**Five-Year Review Report for
Installation Restoration (IR) Site 9 - Operable Unit 1
Marine Corps Base Camp Pendleton
Camp Pendleton, California**

**Five-Year
Review Report**

Appendix A Responses to Regulatory Review Comments Matrix

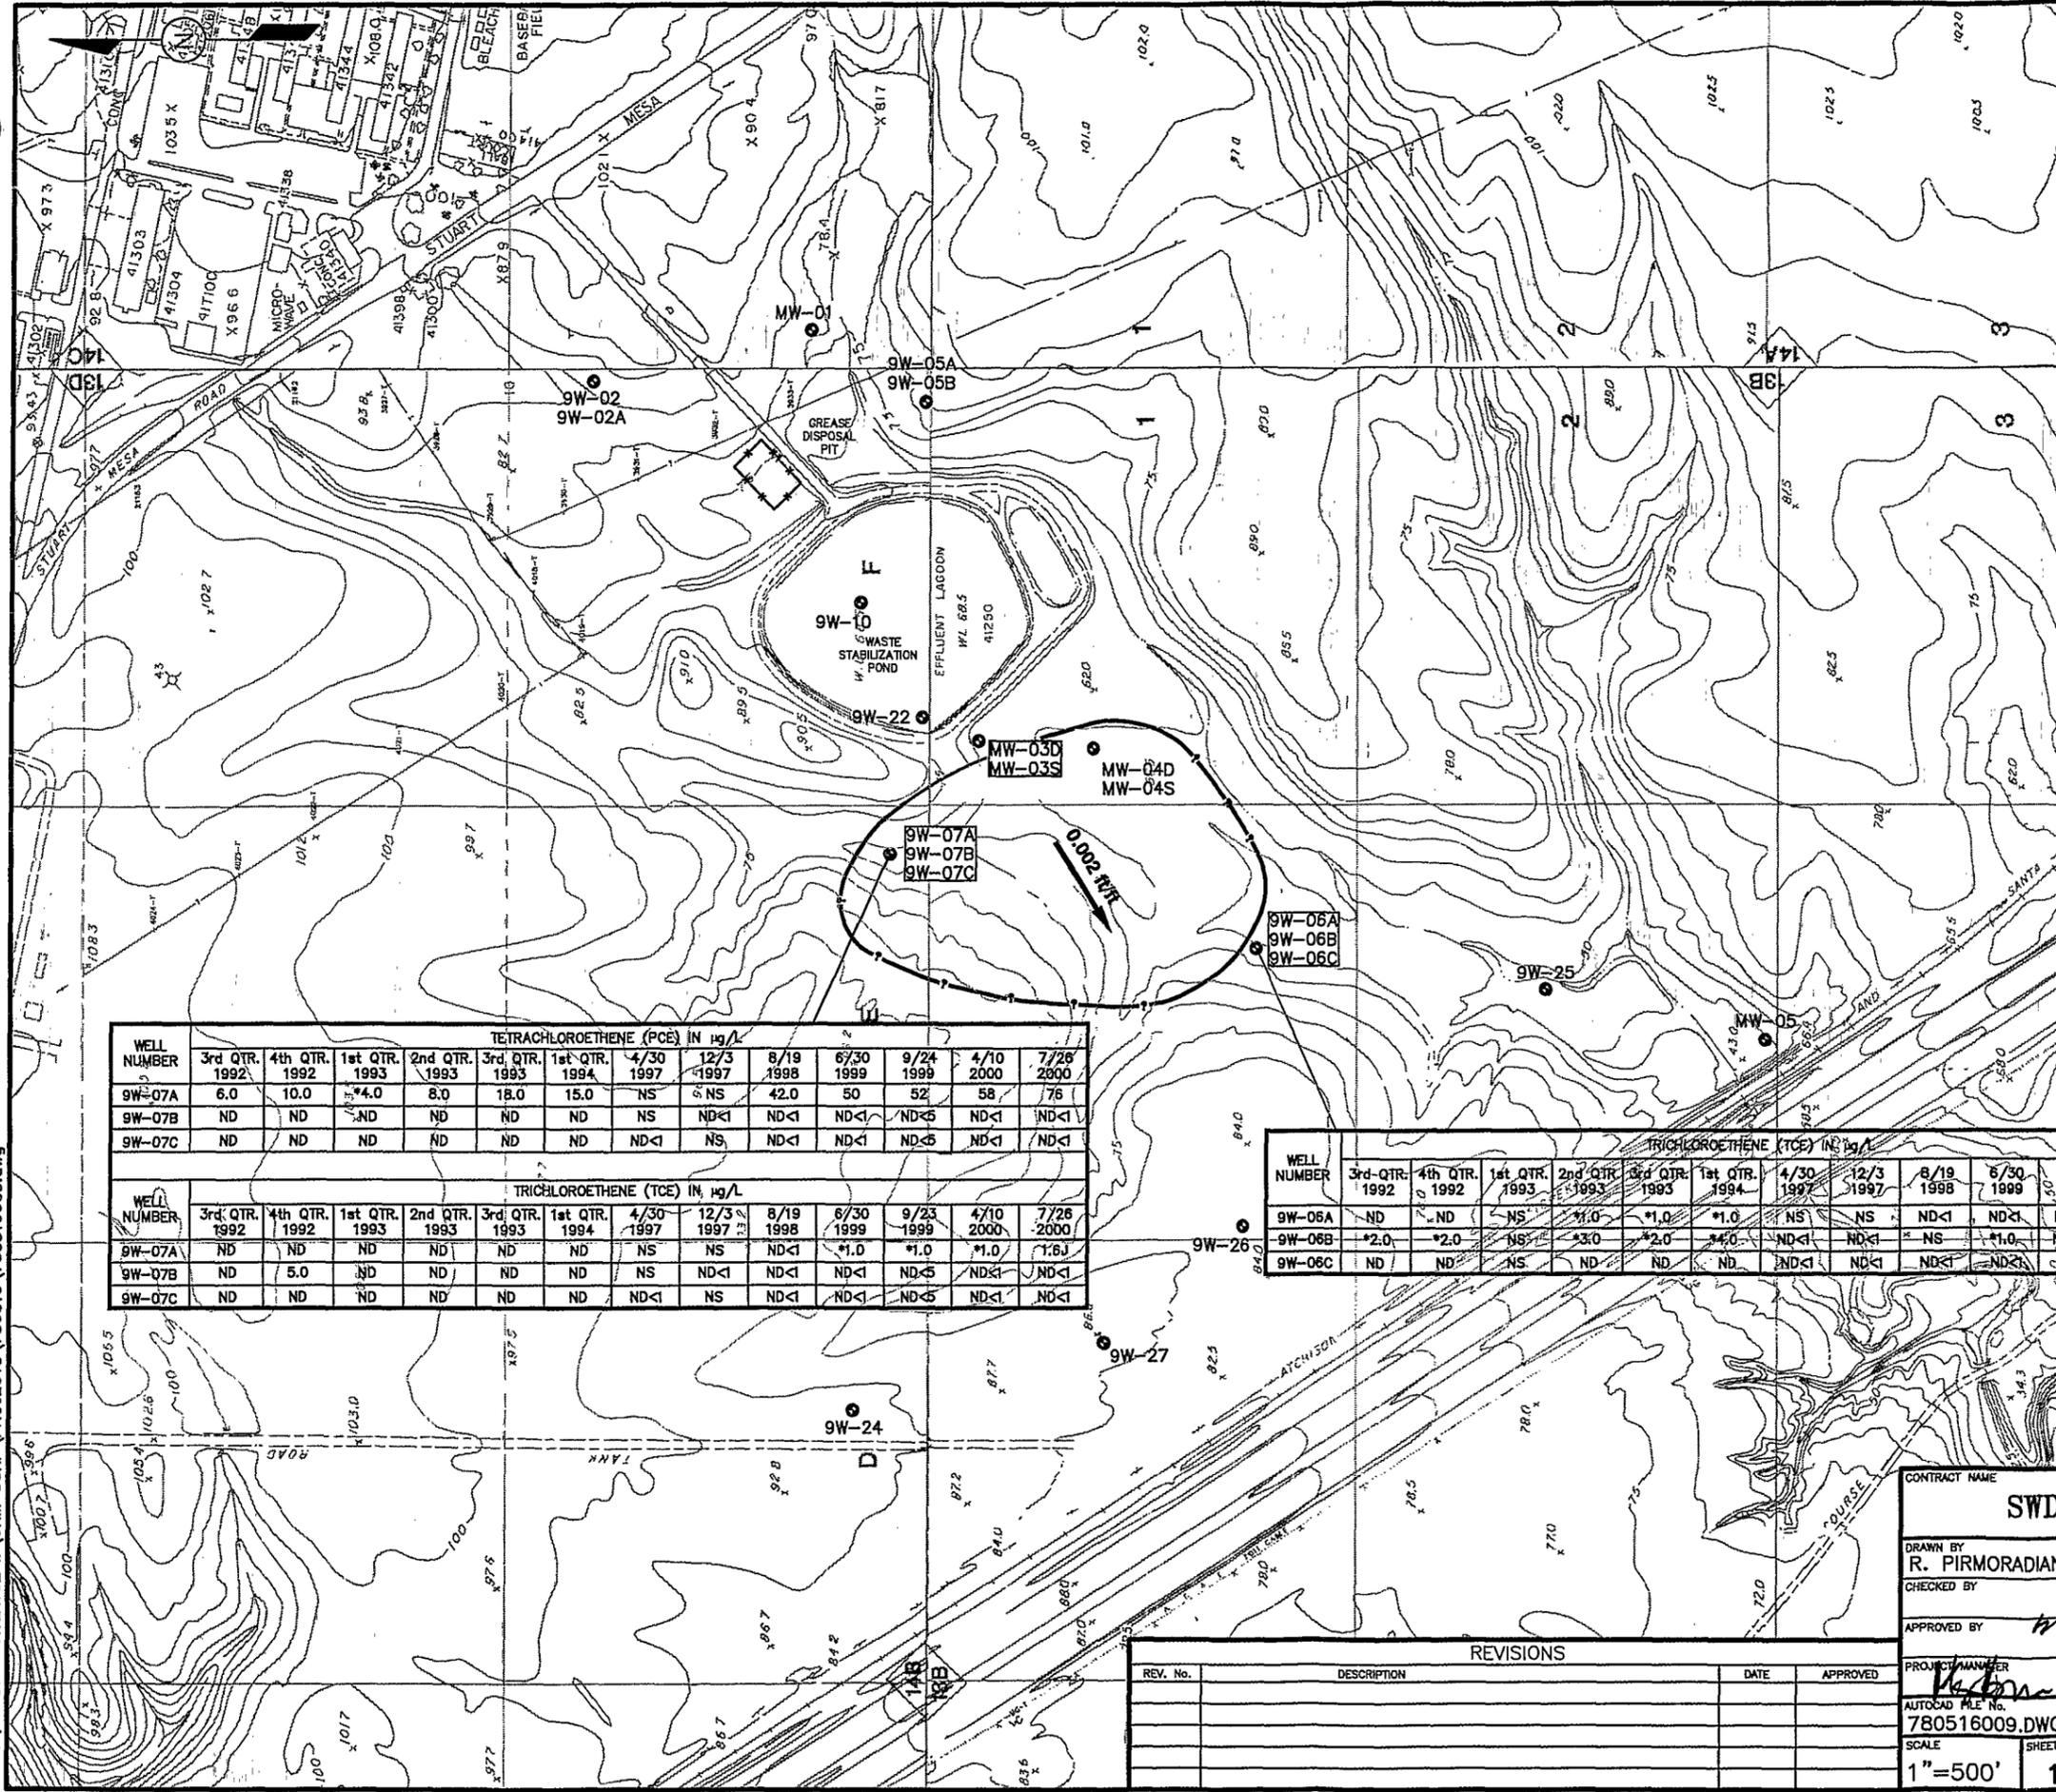
19.	Figures 6-1.	A footnote in this table states: Wells that do not have analytical data corresponding to that well did not have detectable levels of contaminants during the sampling events. While this statement apparently pertains to the ongoing monitoring program, the footnote is not strictly correct because monitoring wells sampled in the RI did show chemicals present, and these data are not shown on Figure 6-1. Other than the three locations of the groundwater monitoring well clusters in the ongoing program, none of the other monitoring wells have been sampled and analyzed, so they would not be indicated on the figure. Most importantly and as noted previously, MW-04D did have TCE concentrations that exceeded the MCL in 1994, but the footnote would suggest that TCE is now non-detect when in fact it apparently has not been sampled and analyzed for TCE since 1994. If subsequent sampling has indicated non-detect levels of TCE in this monitoring well, then please explain why it is still being included within the isoconcentration contour.	Your comments are noted. We will revise the figure to clarify this issue and the fact that only three cluster wells are monitored.
